REF: L1662.2 V2

2nd July 2024

**RE: SEVEN SISTERS INDUSTRIAL UNITS, NEATH PORT TALBOT
STAGE 3 ACOUSTIC DESIGN REVIEW**

FIGURE 3: ACOUSTIC DESIGN INTENT FOR INTERNAL ELEMENTS

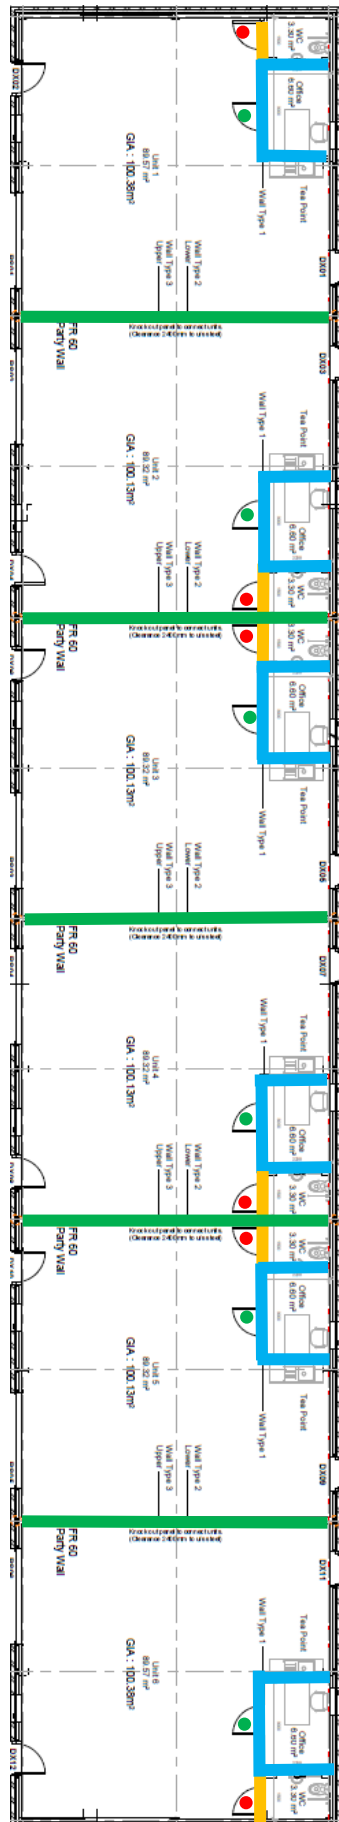
{Note 1} The separation between these rooms contains a connecting door. A door will limit the acoustic separation. To maintain a reasonable separation with a functional door we recommend these doors have an acoustic rating of at least 35 dB R_w and the wall a rating of a minimum 45 dB R_w .

We therefore recommend that additional absorption is included in the form of 35 m² of Class A wall panels. With the inclusion of such a provision, we expected the reverberation time in the workshop to be reduced to 1.5 s and therefore achieve the derived target levels.

Wall Type Ref.	Construction Description	Min Laboratory Performance R_w (dB)	Substantiation Reference
1	Gypframe 70 S 50 C studs at 600 mm cts, 1 x 15 mm Gyproc DuraLine board to both sides	40	Q606062
	Or 100 mm medium density concrete block (minimum density 1400kg/m ²)	45	Estimate
2	Gypframe 70 S 50 C studs at 600 mm cts, 1 x 15 mm Gyproc DuraLine board to both sides, 25 mm Modular Roll in the cavity	45	Q606063
	Or 140 mm medium density concrete block (minimum density 1400kg/m ²)	47	Estimate
3	Gypframe 70 S 50 C studs at 600 mm cts, 1 x 15 mm Gyproc DuraLine board to both sides, 80 mm Modular Roll in the cavity	48	Q606065
	Or 100 mm medium density concrete block, 50 mm cavity, 100 mm medium density concrete block (minimum density 1400kg/m ²)	60	Estimate

Door Type Ref	Dot Colour Key	Typical Construction Description	Minimum Laboratory Performance R_w (dB)
1	●	30 dB R_w laboratory tested riser door set, typically 45 mm solid core door set (door leaf mass of min 23 kg m ⁻²) with perimeter acoustic/smoke seals	30
2	●	35 dB R_w laboratory tested riser door set, typically 45 mm solid core door set (door leaf mass of min 38 kg m ⁻²) with perimeter acoustic/smoke seals	35
